**CITY OF FORT COLLINS
TYPE 1 ADMINISTRATIVE HEARING**

FINDINGS AND DECISION

PROJECT NAME: College and Trilby Multifamily

CASE NUMBER: PDP # 220009

ATTACHMENT A

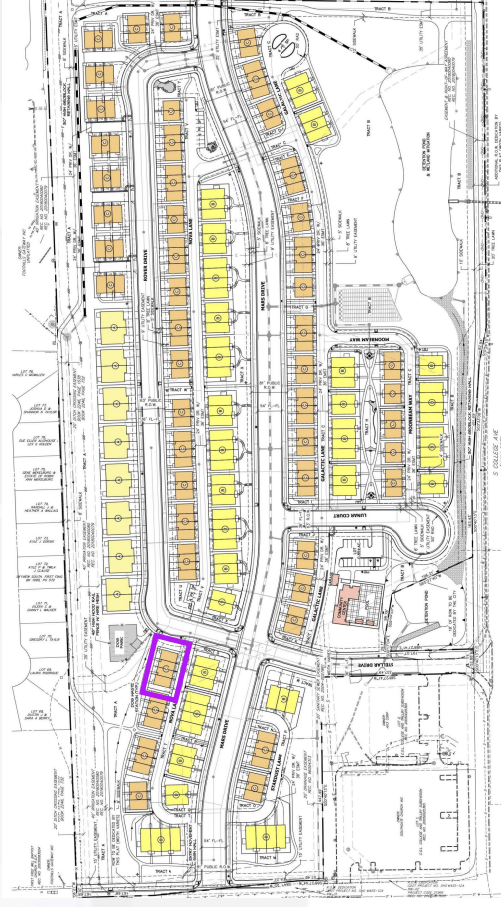
- C. The Modification of Standard to LUC § 3.5.2(C)(2)(a) to allow buildings with duplicate footprints to be placed next to each other in the six regions of the Subject Property shown on ATTACHMENT A to this decision (the "**Affected Regions**"): (i) will not be detrimental to the public good, (ii) will promote the general purpose of subsection 3.5.2(C)(2)(a) equally well or better than would a plan which complies with the standard, and (iii) will not diverge from subsection 3.5.2(C)(2)(a) except in a nominal, inconsequential way when considered from the perspective of the entire PDP and will continue to advance the purposes in LUC § 1.2.2. With respect to the foregoing, the Hearing Officer specifically incorporates the Staff Findings on page 7 of the Staff Report and finds:

- iv. Based on the Applicant's testimony and presentation materials, including ATTACHMENT A to this decision, visually identical buildings will not be placed next to each other within the Affected Regions.

1. The buildings affected by the approved Modifications of Standards shall be identified on the site plan for the PDP and the site plan for the final development plan ("**FDP**") for the Project consistent with what is shown on ATTACHMENTS A and B to this decision. Notes explaining these modifications shall be included on the site plans for the PDP and FDP.

2. Modification of a Standard for Street-Facing Facades – 3.5.2(D)(2)

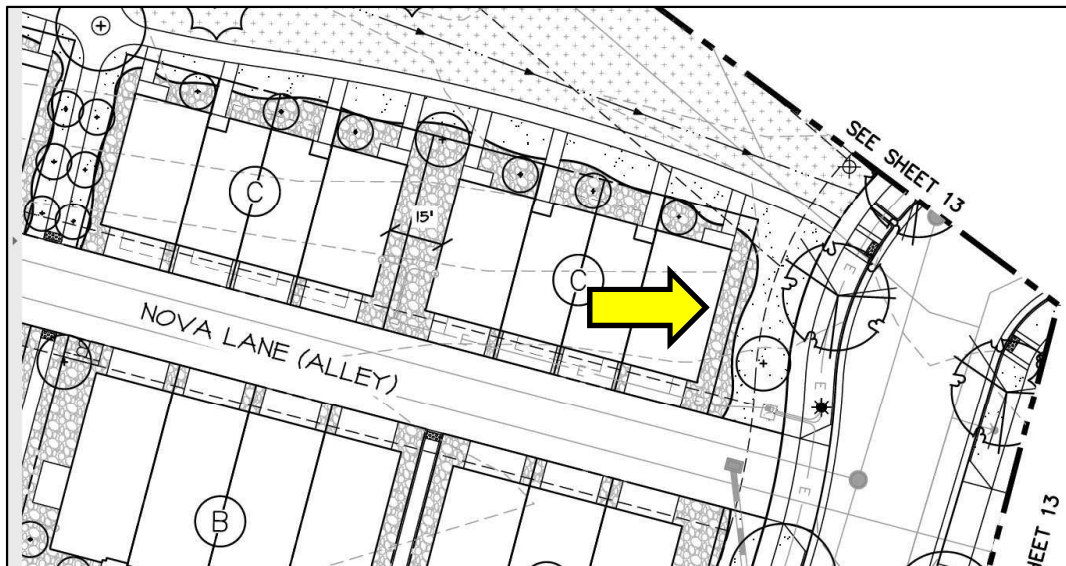
This is one such occurrence out of 85 buildings. The interior of the building is a garage partly below grade, with the grade in the outside yard sloping down along the building wall such that a doorway would be non-functional. The visual impact is mitigated by being located on a curve, and by two trees in the foreground closer to the sidewalk.

Criterion (4), "nominal and inconsequential". From the perspective of the entire development plan, the one end of one building facing Rover Drive without a doorway is nominal and inconsequential for reasons stated above and does not affect the purposes of the Land Use Code.

Staff supports the request for Modification of Standards to subsection 3.5.2(D)(2) for one building that does not have a doorway on an end of the building that faces a local street.
